UNITED STATES PATENT AND TRADEMARK OFFICE

Office Action Summary	Application No. 10/771,753	Applicant(s) WATZ, ROBERT	
	Examiner Aaron R. Eastman	Art Unit 4147

DETAILED ACTION

Figure 4a of Instant Application 10771753

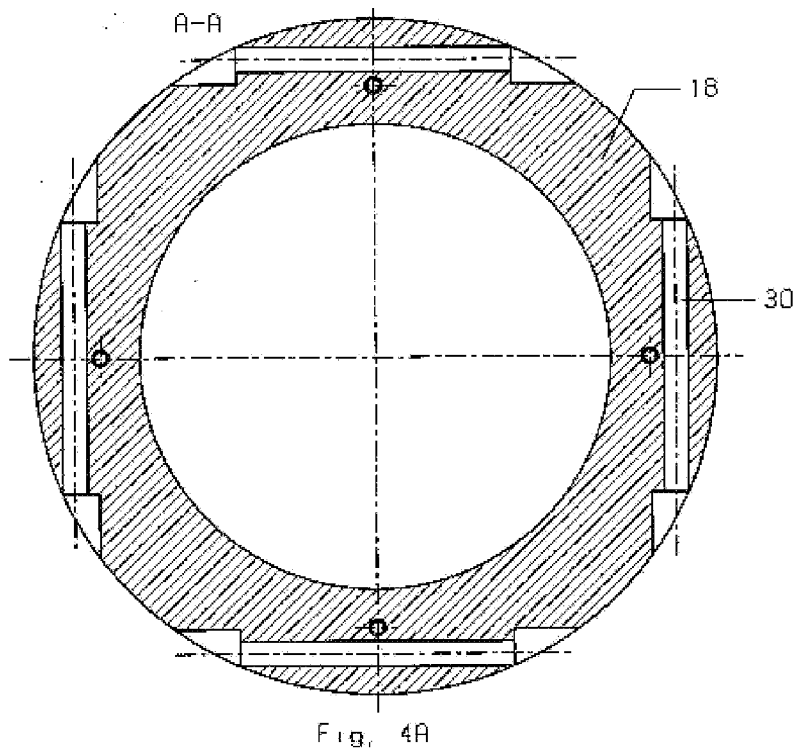
Claim 4 is rejected under 35 U.S.C. 112, first paragraph, as failing to comply with the enablement requirement. The claim(s) contains subject matter which was not described in the specification in such a way as to enable one skilled in the art to which it pertains, or with which it is most nearly connected, to make and/or use the invention. Claim 4 discloses, "...a plurality of bores formed in the component and extending each in a respective tangential direction." This is not supported by the specification, particularly

Figure 4a (see below), when the ordinary meaning of tangent is used as defined by the Merriam-Webster on-line dictionary (www.m-w.com) “meeting a curve or surface in a single point if a sufficiently small interval is considered”.

Figure 1 of Ichikawa et al.

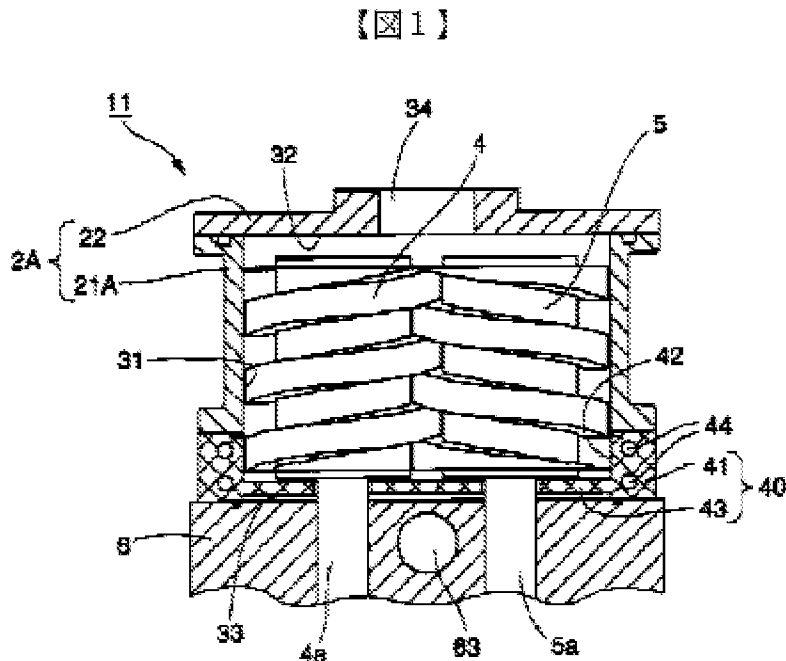
4. Claims 1, 2, 4 and 5 are rejected under 35 U.S.C. 103(a) as being unpatentable over JP 11-315,794 (Ichikawa et al. hereinafter).

5. In re claim 1, Ichikawa et al. discloses:

“A vacuum pump (11), comprising a flange (21a) provided on a suction side of the pump for connection with a connection flange of a recipient (22), and a tempering component (40)” but does not disclose “a tempering component to be arranged between the suction side flange of the pump and the recipient connection flange and including tempering means.”

6. It would have been obvious to one having ordinary skill in the art at the time the invention was made to move the tempering component so that it is arranged between the suction side flange of the pump and the recipient connection flange in order to cool the air that passes through that area.

Figures 2a, 2b and 2c of Ichikawa et al.

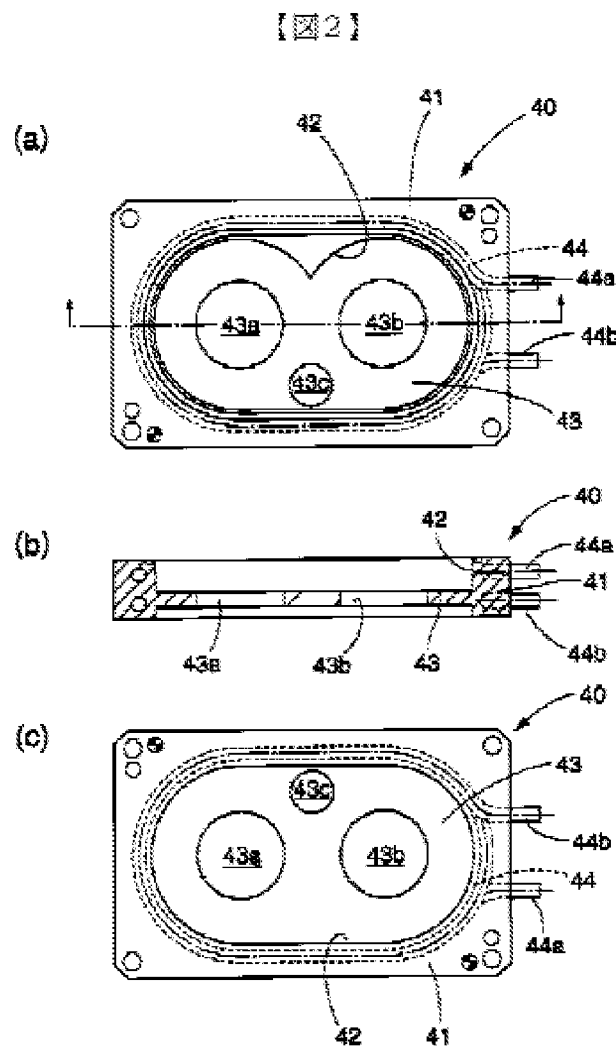
7. In re claim 2, Ichikawa et al. discloses:

"A vacuum pump as set forth in claim 1, wherein the tempering means comprises a circumferential groove (41) provided on the component, and a hollow body (44) received in the groove."

8. Again, while Ichikawa et al. does not disclose a tempering component to be arranged between the suction side flange of the pump and the recipient connection flange, it would have been obvious to one having ordinary skill in the art at the time the invention was made to move the tempering component so that it is arranged between the suction side flange of the pump and the recipient connection flange in order to cool the air that passes through that area.

9. In re claim 4, Ichikawa et al. discloses:

"A vacuum pump as set forth in claim 1, wherein the tempering means comprises a plurality of bores (44, Fig. 1) formed in the component and extending each in a respective tangential direction" as tangent is best understood by the examiner.

Figure 1 of Hettinger

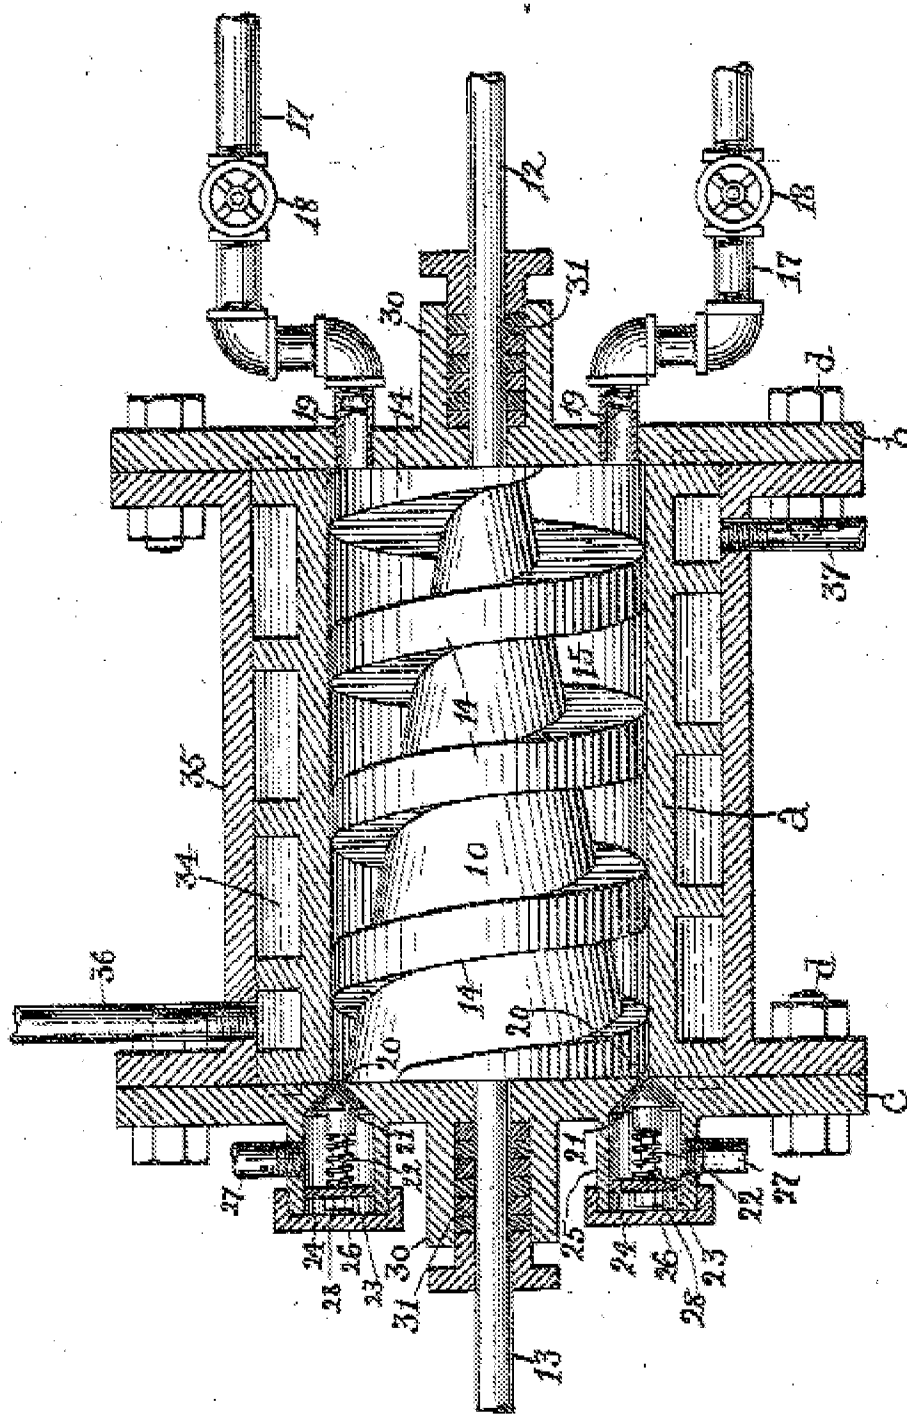
14. In re claim 3, Ichikawa has been discussed above as disclosing “A vacuum pump as set forth in claim 1” but does not disclose “wherein the tempering means comprises a circumferential groove provided on the component, and a hollow body received in the groove” as set forth in the claim. Hettinger discloses: “ ... tempering means comprises a circumferential groove (34) provided on the component (a), and means for closing the groove comprising a sleeve (35) and sealing means (d).”

15. It would have been obvious to one having ordinary skill in the art at the time the invention was made to combine the cooling means taught in Hettinger with the vacuum pump taught in claim 1 as disclosed by Ichikawa et al. in order to effectively cool the pump.

Figure 1 of Reimer

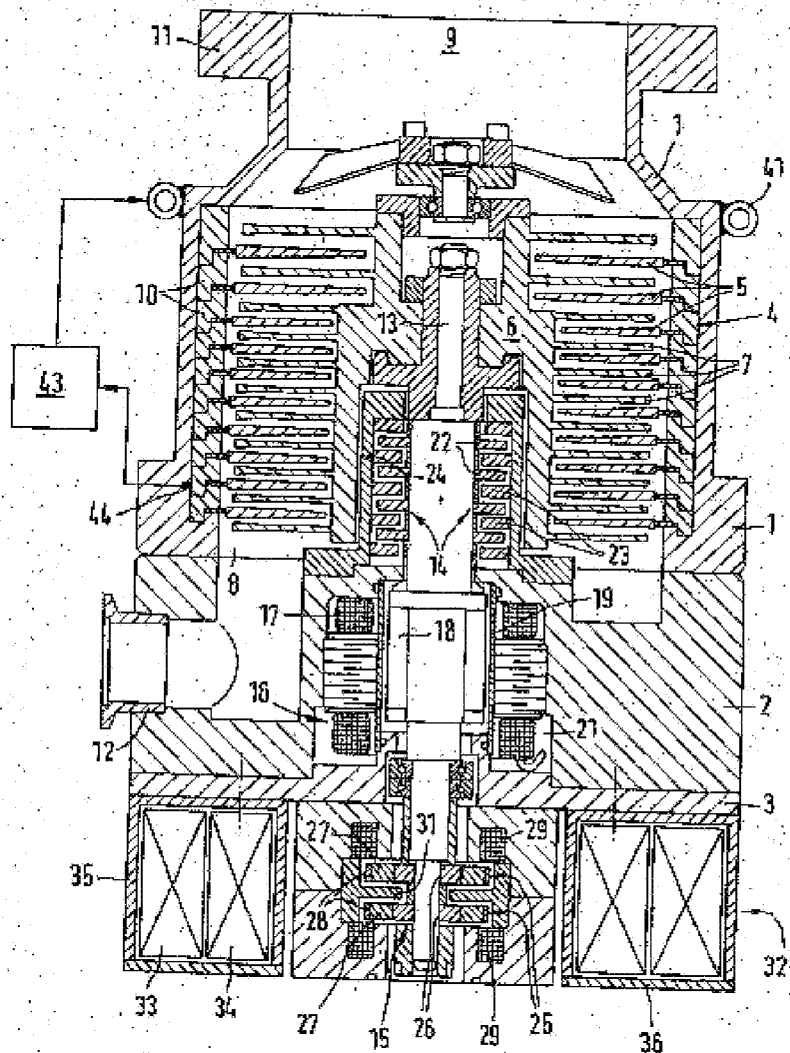
17. In re claim 6, Ichikawa has been discussed above as disclosing "A vacuum pump as set forth in claim 1" but does not disclose "further comprising temperature control means connected with the tempering means" as set forth in the claim. Reimer discloses: "...temperature control means (43) connected with the tempering means (41)."

18. It would have been obvious to one having ordinary skill in the art at the time the invention was made to combine the temperature control means taught in Reimer with the vacuum pump taught in claim 1 as disclosed by Ichikawa et al. in order to regulate the temperature of the cooling fluid.

Figure 1 of Spencer (partial view)

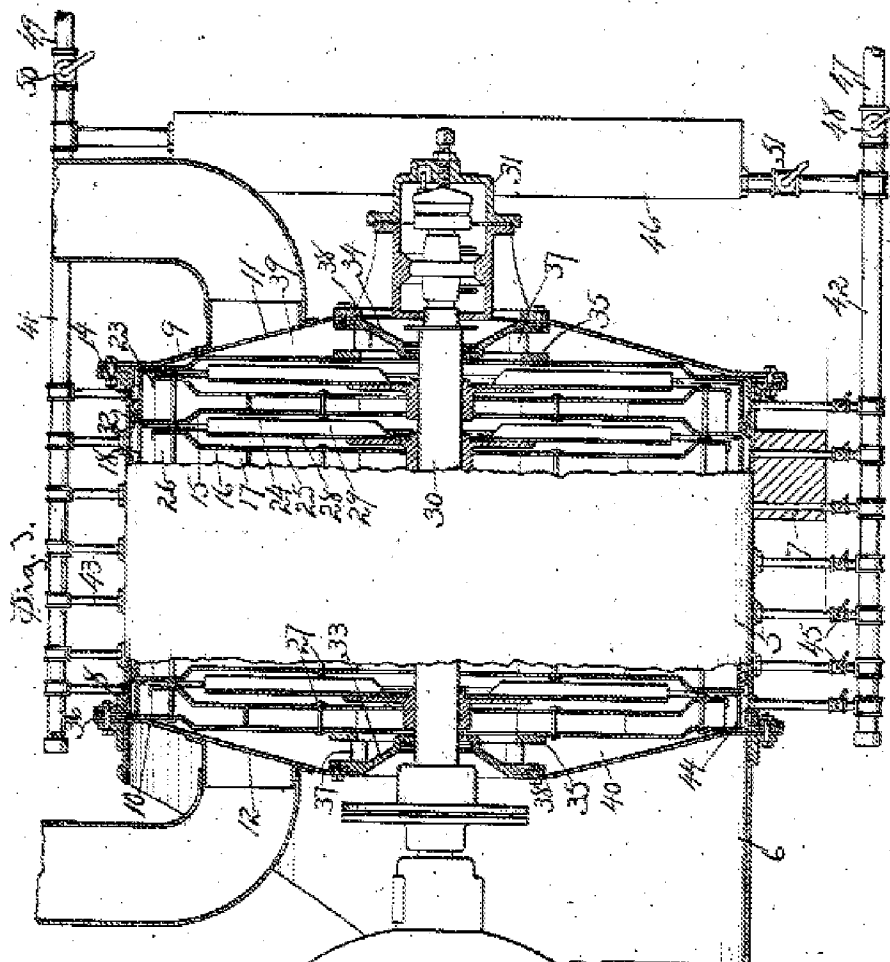
20. In re claim 7, Ichikawa has been discussed above as disclosing "A vacuum pump as set forth in claim 1" but does not disclose, "a plurality of tempering components is provided between the suction side flange and the recipient connection flange" as set forth in the claim. Spencer discloses: "...a plurality of tempering components (comprising 42-51) is provided between the suction side flange and the recipient flange."

21. It would have been obvious to one having ordinary skill in the art at the time the invention was made to combine the plurality of tempering components taught in Spencer with the vacuum pump taught in claim 1 as disclosed by Ichikawa et al. in order to maximize the cooling effect.
